Register Reference : 91A/1425

Development : Development of 80 two storey terraced, semi-detached
houses and bungalows, also shop and creche

LOCATION : off Old Court Road, Firhouse, Tallaght

Applicant : Cunningham Group

Drawn Date 28.9.91
 Check PR Scale 1:500
 Drawing site layout

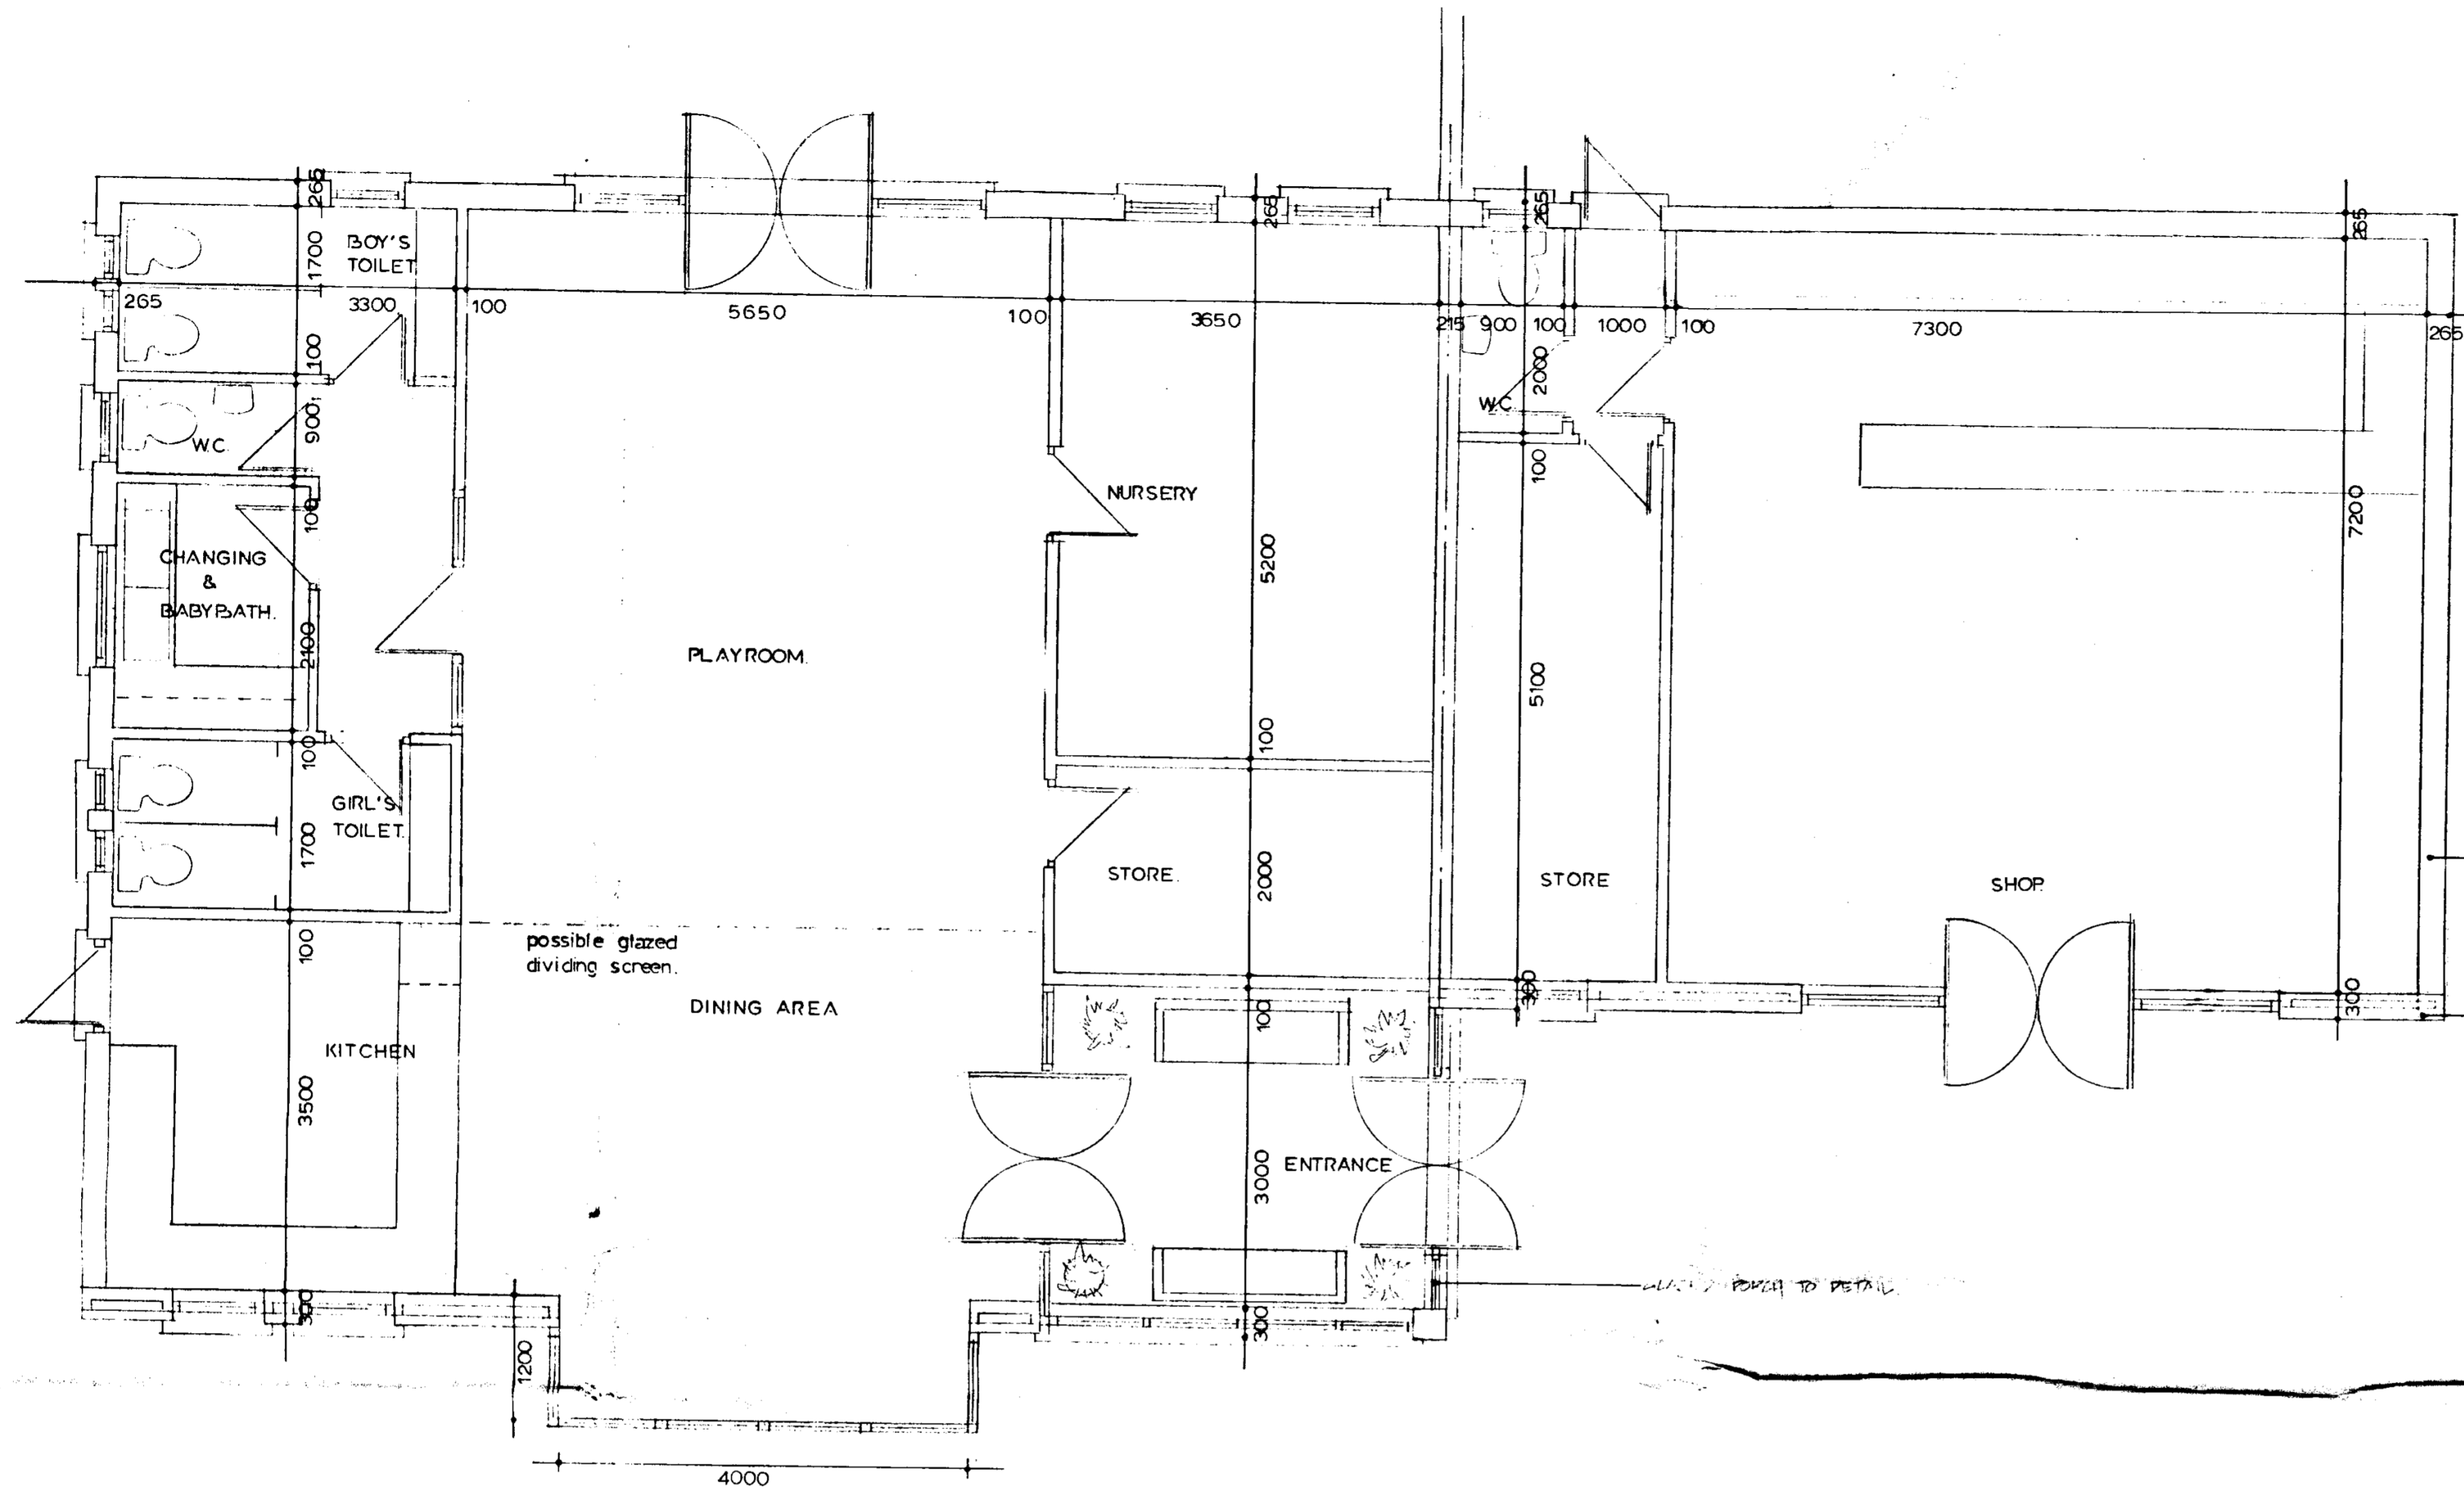
The proposed plan shows a creche, a shop and a parking area, opening onto the road at its most dangerous section. This has to be sheer madness!

The busiest section of the road is, or will be, the most built up section in the plan. We refer to the terrace of 8 houses, proposed, at the junction of Allenton Rd, Oldcourt Rd and the Snake road. The children from Ballycragh Est. cross at this junction when going to and coming from school.

Having seen the plans for the area we can only find two bungalows (Nos. 46 and 47) in Site B. although the specs. state 3 units under the heading of "Bungalows".

The road network is already constructed bar footpaths etc. The cul-de-sac carriageway widths are standard together with the turning circles. However, the applicant indicates only one parking space per dwelling, one short of what is required by 1983 Development Plan Standards. The estate is serviced by newly constructed local distributor leading from the roundabout at the end of Oldbawn Road to Allerton road. By definition frontal access should be prohibited and as such Roads would object to proposed sites 8-15 inclusive.

1. A revised layout with no frontal access onto the local distributor (i.e. eliminate sites 8-15 inclusive).
2. Parking for two cars to be provided on each site.
3. There ~~is~~^{is} a discrepancy between the site layout map & the site location map which places house nos 28 & 29, 62 & 63, 60 & 61, 78 & 79 and the creche & shop in the line of the future distributor road.
4. The proposal does not provide for access to that distributor route (the shop & creche are in the line)
5. Main spine route to be 4.3m wide with 1.5m path & 1.85m verge

- 1) According to the lodged drawing No. 987.12 with the application, no public open space has been shown in association with this residential development of eighty houses, as per the requirements of the 1983 County Development Plan. In lieu of public open space provision, the applicants should be required to provide a financial contribution of £1,000 per site towards the development of public open space at Ballycragh.
